Contract #: 04-0120F4Cty: SF/ALA Rte: 80 PM: 13.2/13.9File #: 69.25B**QUALITY ASSURANCE -- NON-CONFORMANCE REPORT****Location:** Changxing Island, Shanghai, PRC**Report No:** NCR-000151**Prime Contractor:** American Bridge/Fluor Enterprises, a JV**Date:** 21-Jun-2008**Submitting Contractor:** Zhenhua Port Machinery Company, Ltd (ZPMC), Changxing Island**NCR #:** ZPMC-0142**Type of problem:**

Reference Description: Fabricated components that do not conform to working drawings**Description of Non-Conformance:**

Job Name: SAS Superstructure

Subject: NCR No. ZPMC-0142

Shop Drawing Standard Details - Plate Sub-Assemblies & Floorbeams, Sheet No. SD14 Detail "14N", approved on 05-20-2008.

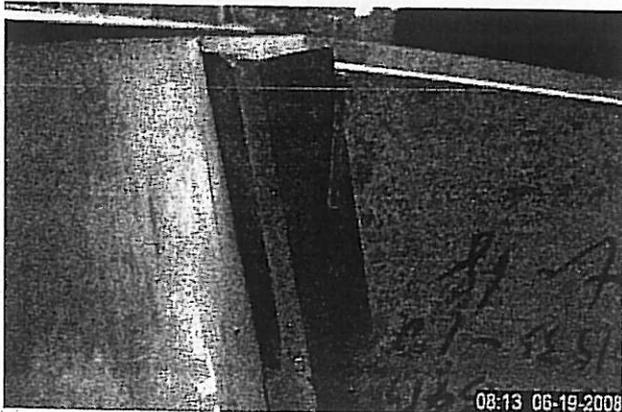
The Contractor fabricated components that do not conform to working drawings. Approved shop drawings require a 40-mm complete joint penetration (CJP) weld length at the ends of OBG closed rib continuity plates. The as built condition for the CJP portion is 100 - 110mm. Below is a digital photograph illustrating the as-built condition prior to welding.

The proposed resolution is acceptable. The Request for Information (RFI) regarding the length of this CJP weld was approved. The Department concurs that Non-Conformance ZPMC-0142 is closed.
